# Work Order ID 97858

Item Name: Crosstube Assembly, Mid Aft

DRAWING NO. D206-667-247	TITLE CROSSTUBE ASS'Y (206L MID AFT)	REV. A	<b>DART AEROSPACE LTD ENGINEERING ORDER</b>		D.E.O. NO. D206-667-247-A-1	SHEET NO. SHEET 1 OF 1	SCALE NTS
DRAWN 92	CHECKED ASS	MFG. APPR. KD	APPROVED JMP		DE APPR. H		
DATE 11.07.15	DATE 11.07.20	DATE 11.07.21	DATE 11/07/21		DATE 11.07.21

**PURPOSE:**

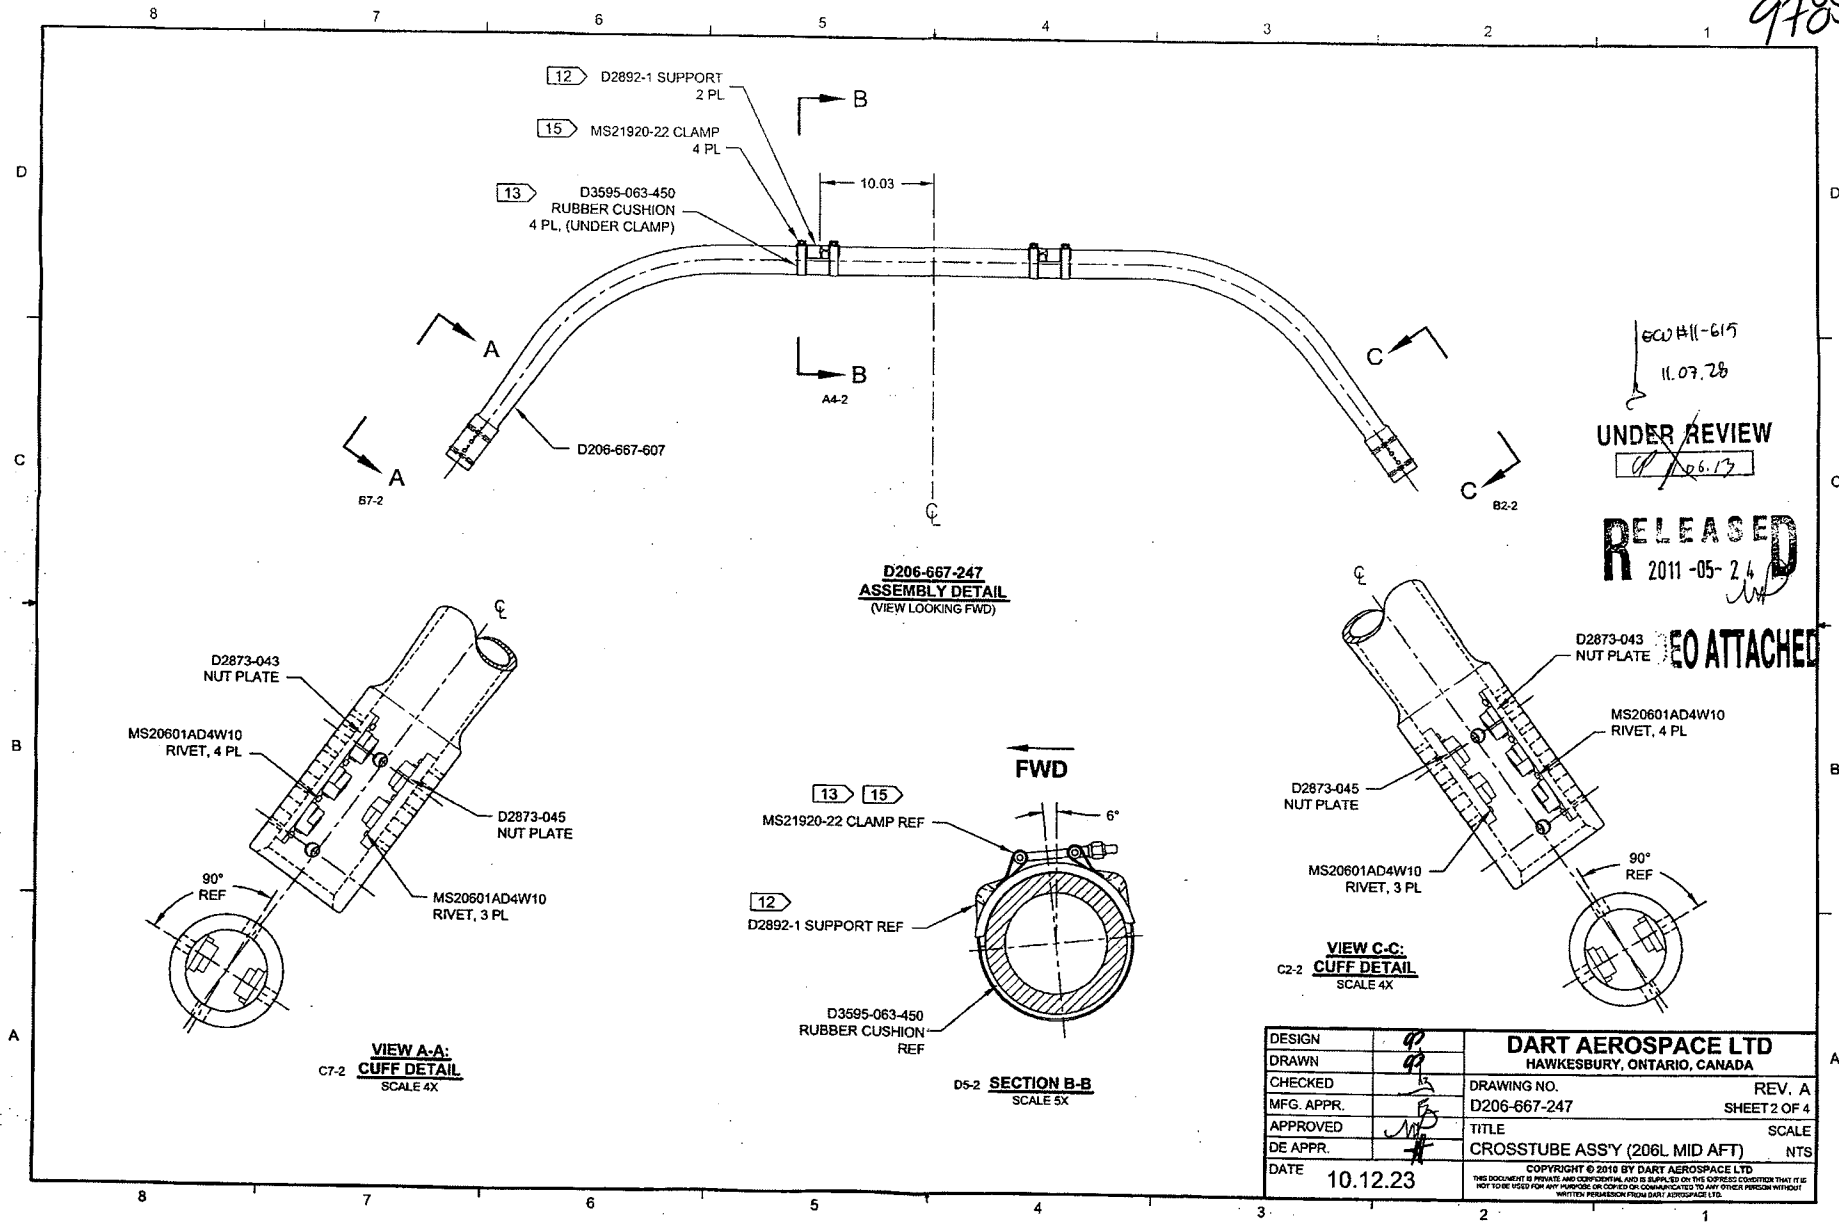
REPLACE MAGNOBOND WITH PROSEAL.

NOTE 12 & 15, SHEET 1 IS AMENDED AS FOLLOWS:

Item	Qty -247	Part Number	Description
9	A/R	PROSEAL 890 B-2	SEALANT, AMS-S-8802 CLASS B-2

- 12) TO INSTALL D2892-1 SUPPORT: ABRASE MATING SURFACE OF SUPPORT AND CROSSTUBE WITH 180-GRIT SANDPAPER AND REMOVE RESIDUE WITH MEK (OR EQUIVALENT). APPLY A 0.04" TO 0.07" THICK LAYER OF PROSEAL 890 CLASS B-2 (OR AMS-S-8802 CLASS B-2) SEALANT TO MATING SURFACE OF SUPPORT.
- 15) TORQUE CLAMPS 80 TO 100 IN-LB. ENSURE AT LEAST 1.5 THREADS SHOWING IN SAFETY AND THAT NUT HAS NOT BOTTOMED-OUT AFTER TORQUING. **PRIOR TO PACKAGING, RE-CHECK TORQUE ON CLAMPS AFTER PROSEAL 890 SEALANT HAS CURED FOR 72 HOURS.**
